**Horsham
District
Council**

Gatwick Airport Northern Runway Project

Response to Additional Documents submitted at Deadline 3 Case for the Scheme and Related Matters

**Gatwick North Runway Project
Response to Additional Documents submitted at Deadline 3
Case for the Scheme and Related Matters**

Figure 1: Peak Week Runway Utilisation Summer 2024³

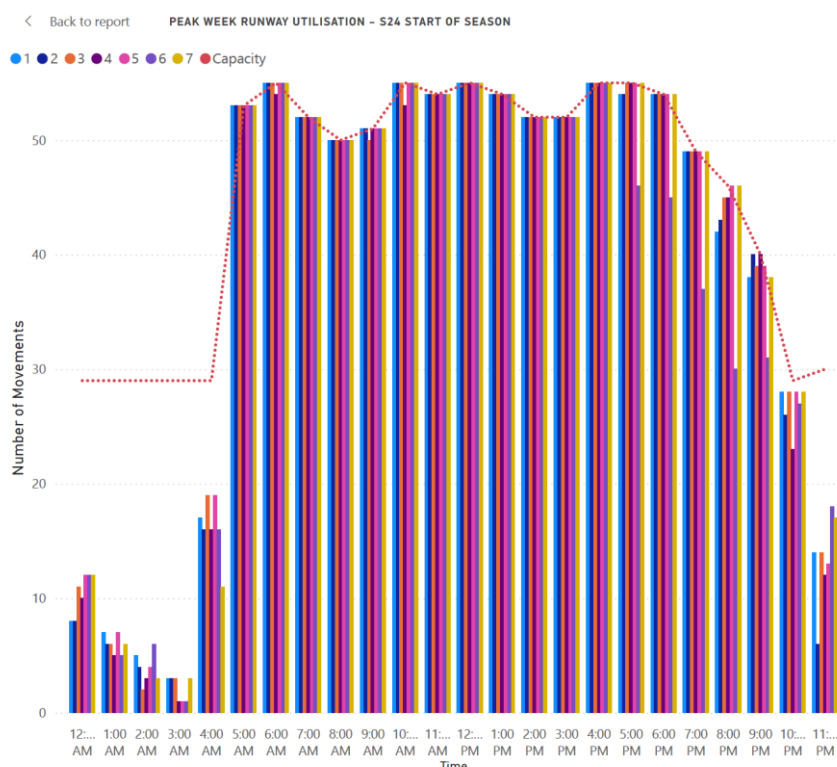
20. Although GAL suggests, at paragraph 4.1.16 of **REP3-079** that the airlines oversubscription of slots indicates that they do not see current levels of delay as an impediment to operations, it does not indicate that airlines would still be willing to operate if delay levels increased as a consequence of scheduling more flights over a busy day. Rather the fact that airlines are not willing to adjust their flight timings to take up the remaining spare slots, as illustrated in **Figure 1** below², highlights why GAL’s assertion that it can continue to materially grow the number of annual aircraft movements within the runway capacity it has assessed for the Baseline Case is implausible. The 7% growth claimed by GAL for 2024 reflects continued recovery at Gatwick towards the level of annual movements attained in 2019, when the Airport was operating at full capacity, not growth above that number.
